## REMARKS

Upon entry of this Amendment, claims 1-22 will be pending in the application. Formal drawings (sheets 1-4, Figs. 1-4) are submitted herewith as an attachment to this Amendment. Figs. 2 and 4 have been amended.

Fig. 4

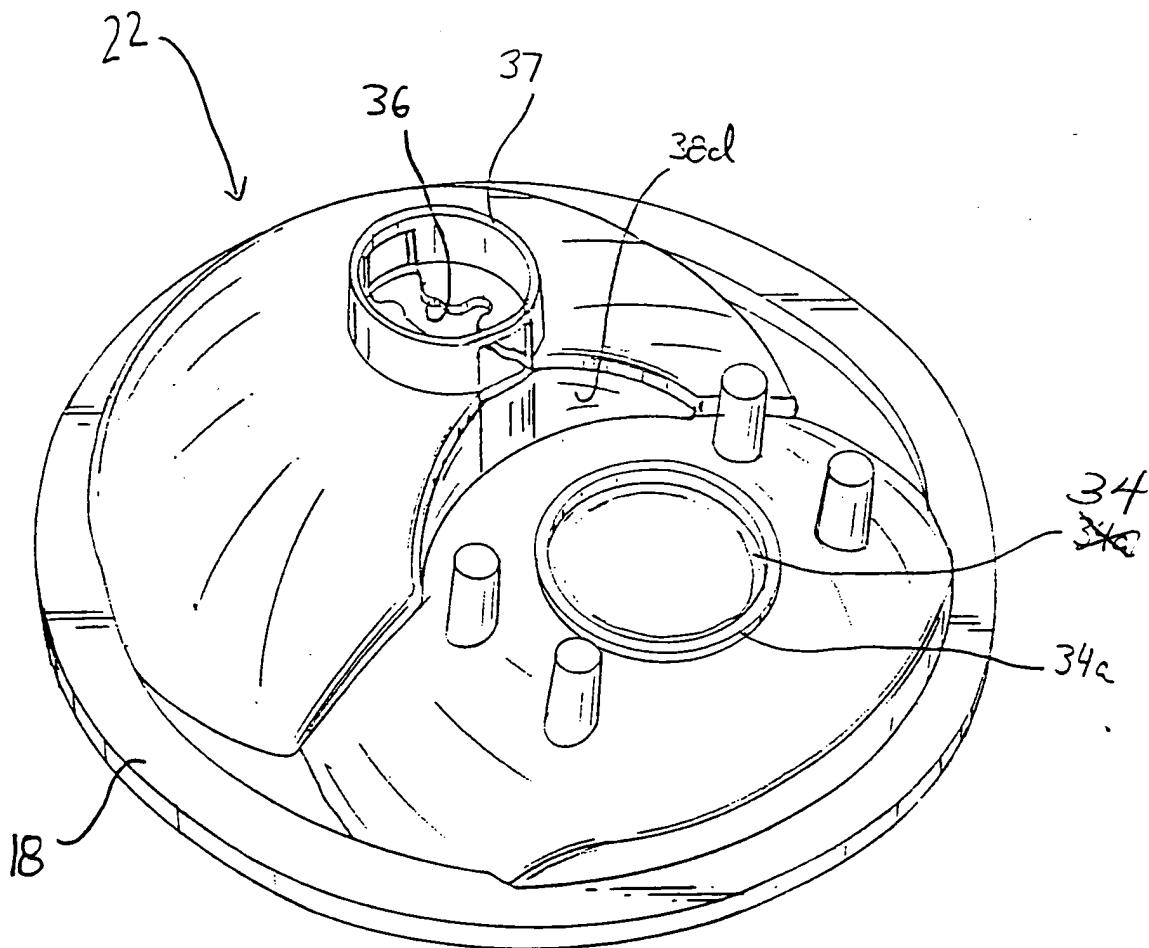
The drawings have been objected to under 37 C.F.R. 1.84(p)(4) on the ground that reference character "34a" has been used to designate both opening and seats in Fig. 4.

In response, Applicant has amended Fig. 4 to designate the opening with reference numeral 34. A marked-up copy of original Fig. 4 is attached to this amendment that clearly shows the requested change. Approval and entry of replacement Fig. 4 and withdrawal of this objection are respectfully requested.
